**MFN 05-133**

## **Responses to DSS-CD TRACG LTR RAIs**

### **Non-Proprietary Version**

**Figure 4-1. Convective Terms at a Junction Between Components Using Different Numerical Methods.**

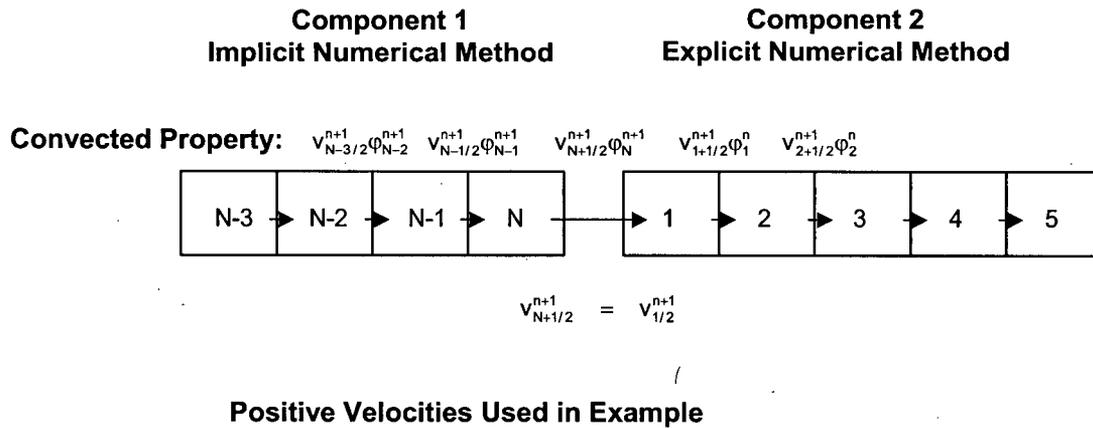
Is the numerical method selected on a component by component basis? If so how are the inconsistencies between numerical methods handled to ensure conservation of mass and energy at boundaries between explicit and implicit components?

The numerical method is selected on a component-by-component basis. For applications to stability the explicit integration is used for the channel component, other components use the implicit numerical method. When a component using an implicit numerical method is connected to a component using the explicit numerical method, the new time step fluid properties are convected between the two components. Thus the component using the implicit numerical method is fully implicit for all nodes. The explicit component is fully explicit for all nodes except for a node connecting to an implicit component, which will use a mixture of old time step and new time step properties in the convective terms. Old time step properties are used in the convection to other cells in the explicit component and new time properties are used in the convection at a face connecting to an implicit component. See also Figure 4-1, that shows the choice of old time step property " $\phi^n$ " or new time step property " $\phi^{n+1}$ " for the convective terms for a combination of two components using different numerical methods. With this approach mass and energy balances are conserved.
